OSBORN & VANE ARCHITECTS INC

ADDENDUM NO. 1

Re: Landlord Work for a
Future Dollar Tree
12466 IH 45, Suite C
Willis, Texas
Project No. 25061

01 PARTIAL
SITE PLAN
SCALE: 1" = 30'

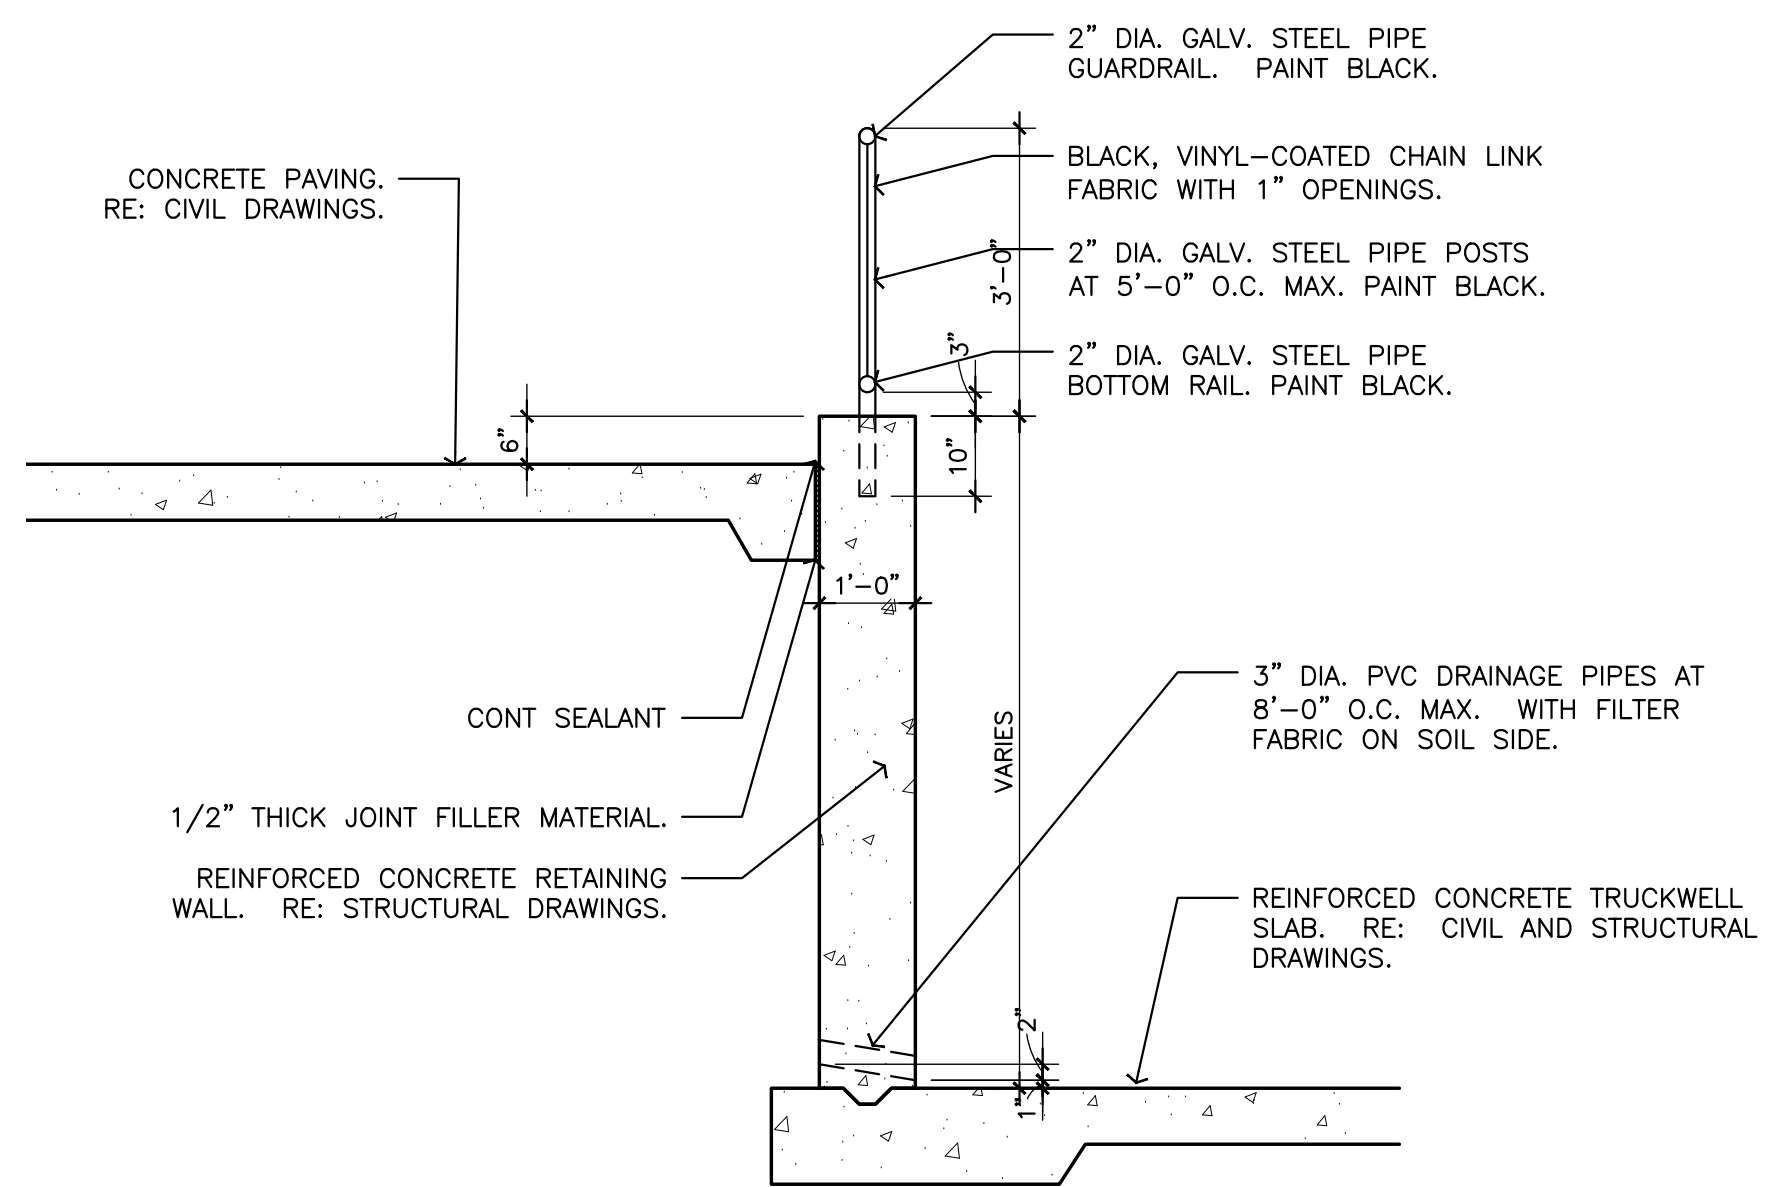
- Item No. 1: See attached Sheet A1.1 noting the removal of the accessible parking from the scope of work. The parking signs and graphics are existing.
- Item No. 2: See attached Sheet A1.2 with the details for the proposed dumpster enclosure including gates and bollards. Also included is the detail for the guard rail at the truck well.
- Item No. 3: See attached Sheet A2.0 showing the revised size of the leave-out in the future Dollar Tree lease space. Also noted are bollards at the rear of the building.
- Item No. 4: Provide control joints in the soffit between each light fixture. See detail 05/A2.1.
- Item No. 5: See attached Foundation Plan showing the revised size of the leave-out in the future Dollar Tree space and the missing slab thickness and reinforcing.
